**ADDENDUM NO. 2  
Issued April 14, 2009**

**REQUEST FOR BIDS  
FOR  
COMPLETION OF CLOSURE  
OF THE  
PHASE 1 ASH AREA  
AT THE  
HARTFORD LANDFILL  
(RFB Number FY09-EN-004)  
(RFB Issued March 18, 2009)**

This Addendum consists of CRRA's responses to written questions received by 3:00 p.m., April 7, 2009, the due date specified in the Contract Documents. Because of changes resulting from various answers, the Bid Price Form has been revised as have Plan Numbers D-3 and D-4. These documents are attached to this addendum and revised documents have been posted on CRRA's web page.

D-3

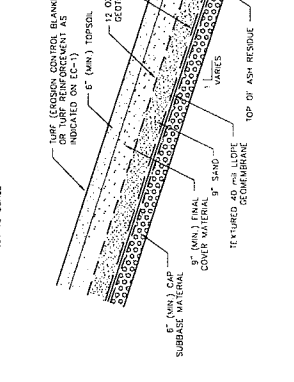
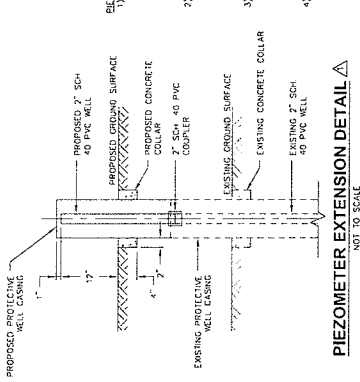
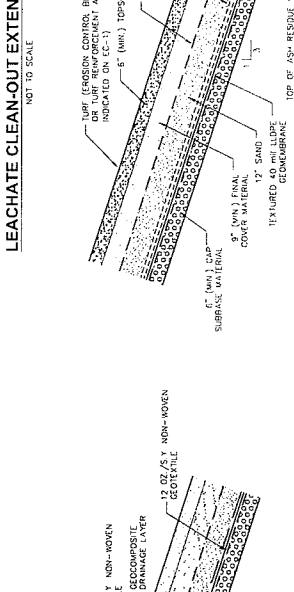
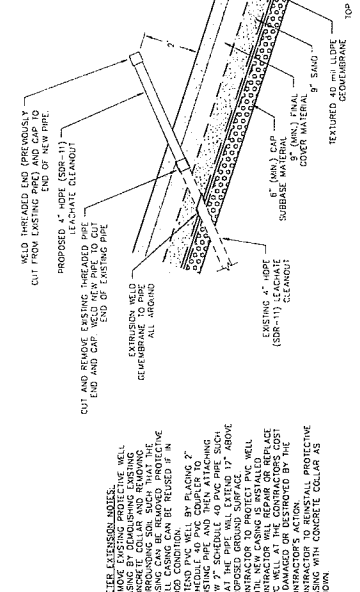
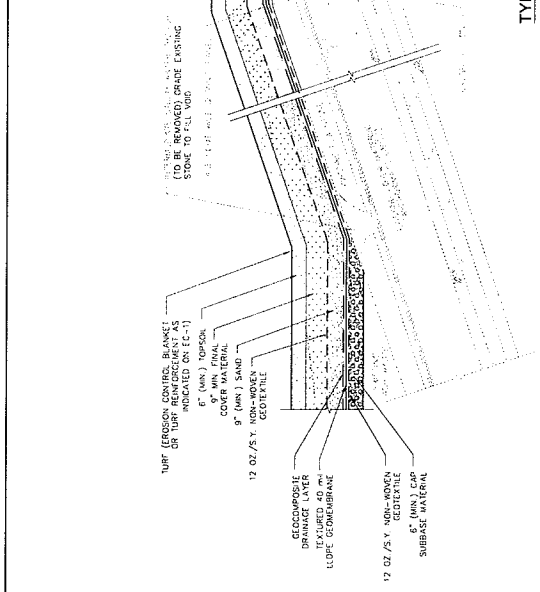
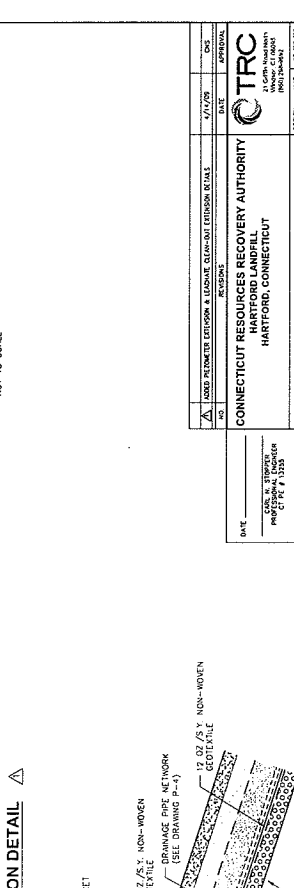
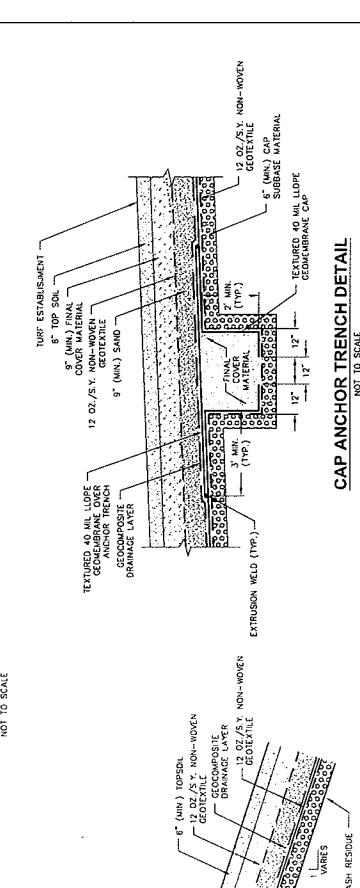
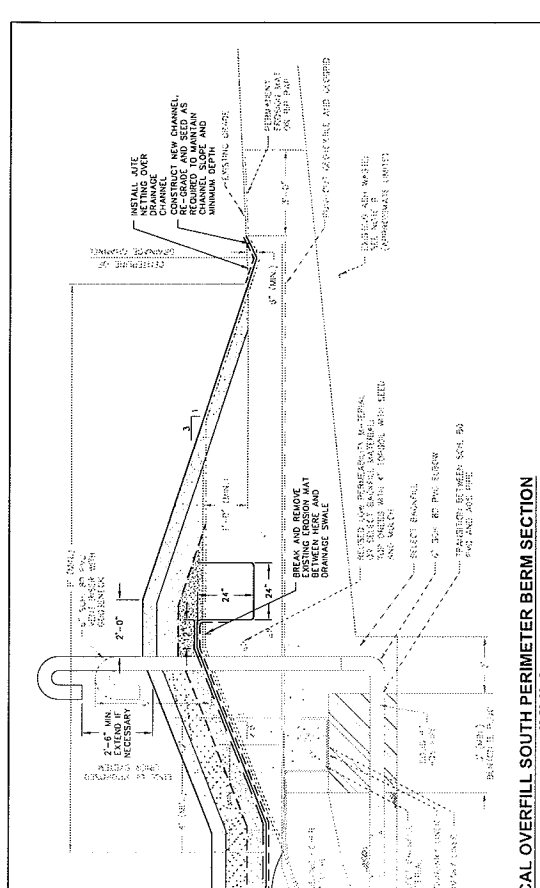
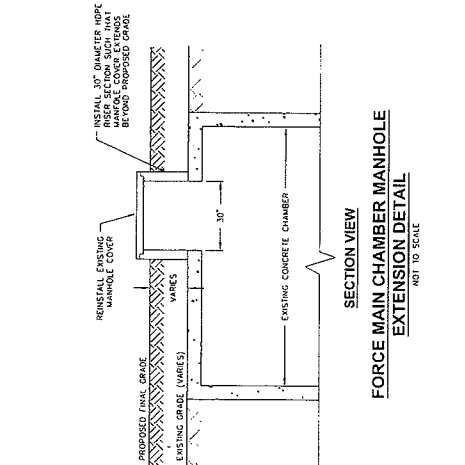
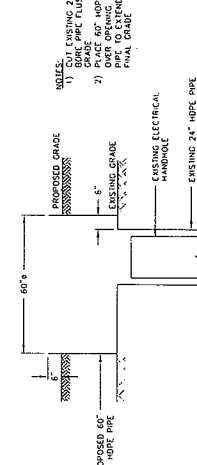
Answer	A description has been added to bid item No. 36 for this cleanout of an existing drainage structure.
<b>2.5</b>	Question	Please provide a detail and/or specification on Bid Price Item 39 - Piezometer Extensions.

<b>3.1</b>	Question	Sheet D-2, Existing Cap and New Final Cap Interface detail, indicates that the depth of sand above the half pipe on the east slope will be nine inches. Is the depth also nine inches for the area above the half pipe on the north slope?

Answer	There is a discrepancy between sheets D-2 and P-5. The Round Drain Pipe is used in 9 locations as indicated on P-5.
<b>3.3</b>	Question	Please furnish a detail for the extension of the piezometers.

<b>3.11</b>	Question	Sheet D4 shows a liner boot detail for the 24" pump access pipe. Are there specific booting requirements for any other structures within the limits of the cap (Force Main Chambers, Electrical Handholes, Electrical Panel, Pipe Extensions)
	Answer	See the answer to question 3.10 above.
<b>3.12</b>	Question	What is the size of the force main for extension? Is there a detail of what is expected?
	Answer	Please see sheet D-3 for detail on the force main extension.

Answer	See the attached modified Sheet D-3.
<b>2.6</b>	Question	Are the correct specification sections listed in Unit Price Bid Item 2 in the Bid Price Form?

Answer	See Sheet D-3 which indicates the limit of the drainage geonet and that, for the area above the half-pipe on the north slope, 12" of sand is to be used. Where the drainage geonet is used the Contractor shall use 9" of sand. Where flat drainage pipe is used the Contractor shall use 12" of sand.
<b>3.2</b>	Question	Sheet D-2, Typical North and East Exterior Berm Section, states that the 4-inch Round Drain Pipe is used in six locations. Should this be nine locations?

Answer	A piezometer extension detail and a leachate clean-out detail have been added to Sheet D-3 (see attached drawing).
<b>3.4</b>	Question	What is the pipe material and size for the pump access that will be extended as shown on sheet D-4?

Answer	The structures that require "collar" installation or extension that will penetrate through the final membrane include 4" HDPE Leachate System Cleanouts, Electrical Handholes, Piezometers, Pump Access Pipes, Force Main Cleanouts, and the Force Main Chambers. All of these are located on the exterior perimeter berm and the detail will not be modified except for the 4" HDPE Leachate System Cleanouts and the Pump Access Pipes. The Pump Access Pipe detail (sheet D-4) already calls for the membrane to be welded to the pipe but will be modified to call out the pipe size, material, and thickness. A detail is needed for the Leachate System Cleanouts and will be added along with the piezometer extension detail on the modified sheet D-3.

- FORCE MAIN CLEAN-OUT EXTENSION DETAIL**  
NOT TO SCALE
- NOTES:**
- 1) REMOVE EXISTING PROTECTIVE WELL CASING.
  - 2) BELL NEW RISER SECTION TO EXISTING CLEAN-OUT WITH FLANGED COVER AND WELD EXTENSION SUCH THAT THE FLANGE WILL BE APPROXIMATELY EVEN WITH PROPOSED GROUND SURFACE.
  - 3) PROJECT PIPE DURING CONSTRUCTION TO PROTECT PROTECTIVE WELL CASING.
  - 4) 12" CSP PIPE TO PROTECTIVE FORCE MAIN CLEAN-OUT AS SHOWN.

DATE: 07/17/09  
 DRAWN: MJE  
 CHECKED: JMB  
 SCALE: 1/4" = 1'-0"  
 PROJECT: 13300-0000-0000  
 DRAWING: D-4

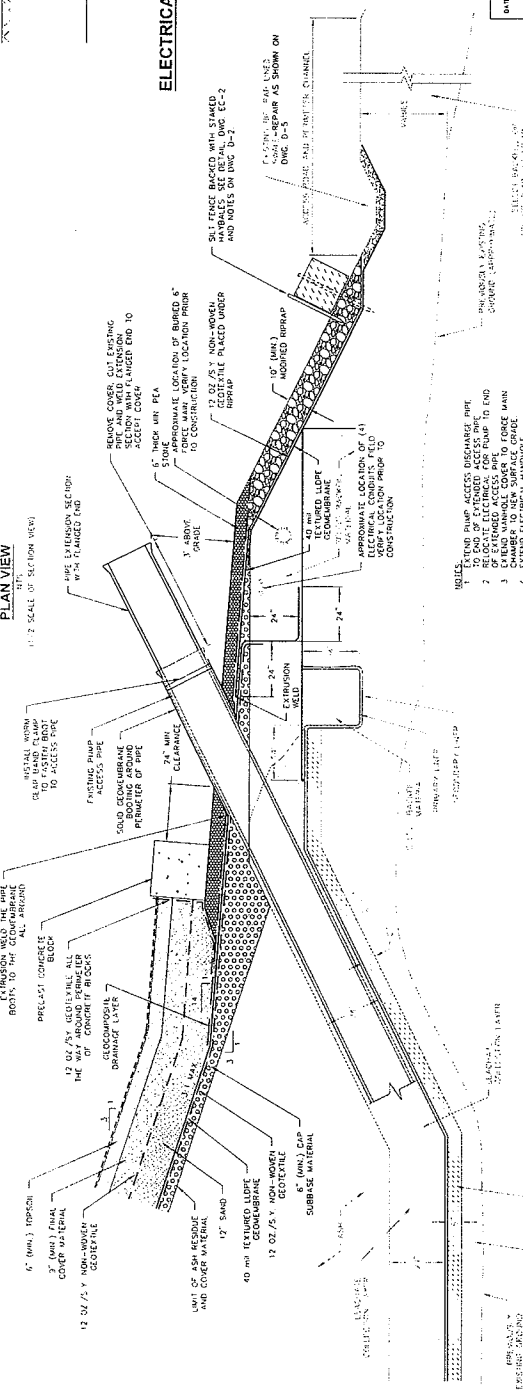
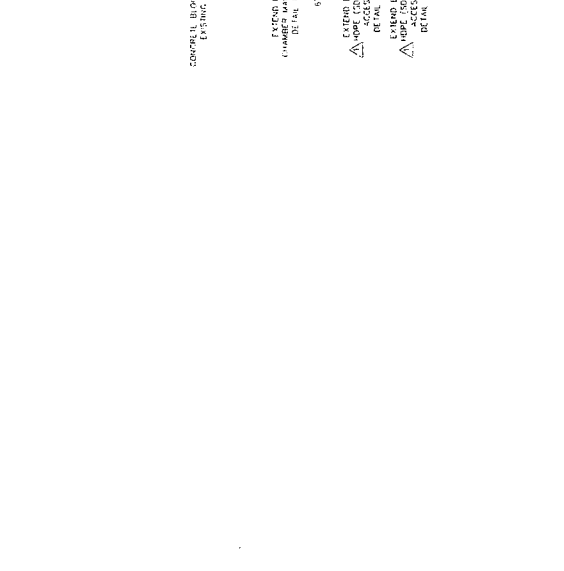
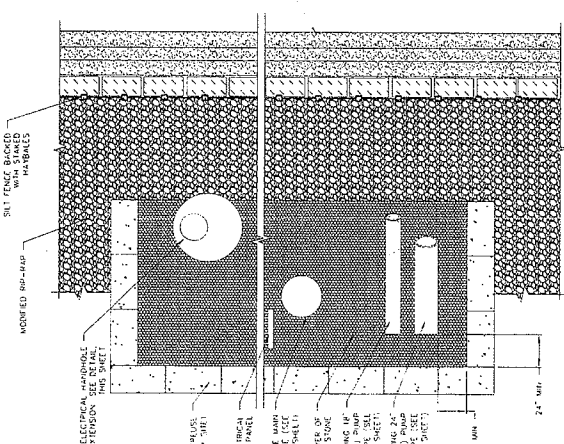
Answer	The two pipes are 24" and 18" SDR-11 HDPE. Sheet D-4 has been modified to show this (see attached drawing).
<b>3.5</b>	Question	The detail on Plan Sheet D-4 shows an extension to the previously-installed pump access discharge pipe. Neither the detail nor the specification gives us the pipe size or wall thickness: SDR-26, 18, 21, etc. Please provide further information on the size and type of pipe required.

Answer	See Answer to Question No. 3.4 above.
<b>3.6</b>	Question	Is the proposed access road on the South side of the site already in place, or does it need extensive grading to build?
